### NOTICE OF VIOLATION

On August 21, 2024, Energy Safety conducted an inspection of SCE's WMP initiatives in the vicinity of the city of Porterville, California. The inspection report is enclosed herewith. Energy Safety found the following violation(s):

# **INSPECTION REPORT**

Electrical Corporation:	Southern California Edison Company				
Report Number:	CADSCE_CAC12_20240821_1346				
Inspector:	CAC12				
WMP Year Inspected:	2023				
Quarterly Data Report (QDR) Referenced:	ort (QDR) Referenced: Quarter 4 (Q4)				
Inspection Selection:	Energy Safety viewed the contents of the Q4 QDR and performed an analysis that resulted in the selection of				
	the WMP initiatives and locations referenced in this report.				
Relevant WMP Initiative(s):	8.1.2.1.1 Covered Conductor				
Date of inspection:	August 21, 2024				
City and/or County of Inspection:	Porterville, Tulare County				
Inspection Purpose:	Assess the accuracy of Southern California Edison Company's QDR data, completeness of its work, compliance				
	with WMP requirements, and compliance with its protocols.

Item1IA1Img1: No Covered Conductor Present

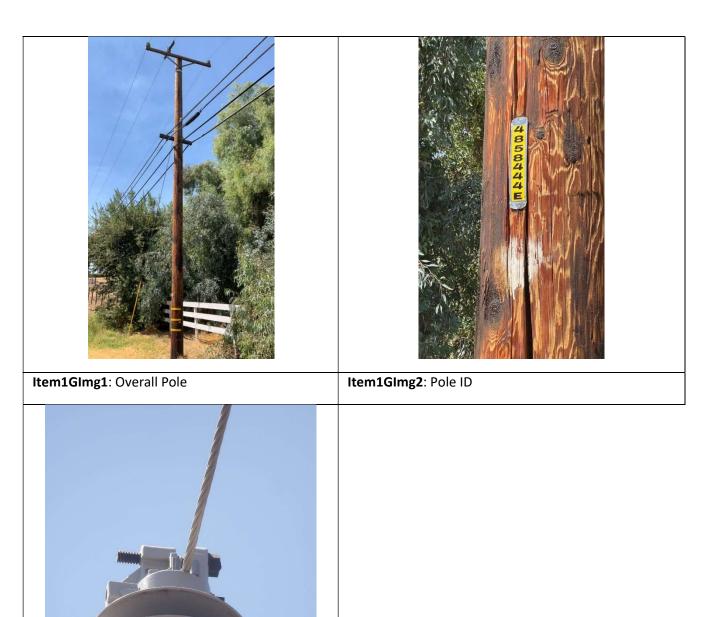
On Pole ID 4858444E, Grid Hardening ID TD2021378-4858444E at 32622 Success Valley Dr, Porterville, CA 93257, 36.065657 -118.869283, the inspector observed that no covered conductor was present. Additionally, the pole with the identification 4858444E did not support a pole with covered conductor installed via a guy line. The inspector's observation is documented in Violation 1 photographs, which are attachments to this report. Photo numbers Item1GImg1, Item1GImg2, and Item1IA1Img1, depict that no covered conductor was installed at the location.

- 1. Data provided by Southern California Edison Company identified that 2023 WMP Covered Conductor (8.1.2.1.1) work was completed at the location.
- 2. Covered conductor was not installed.
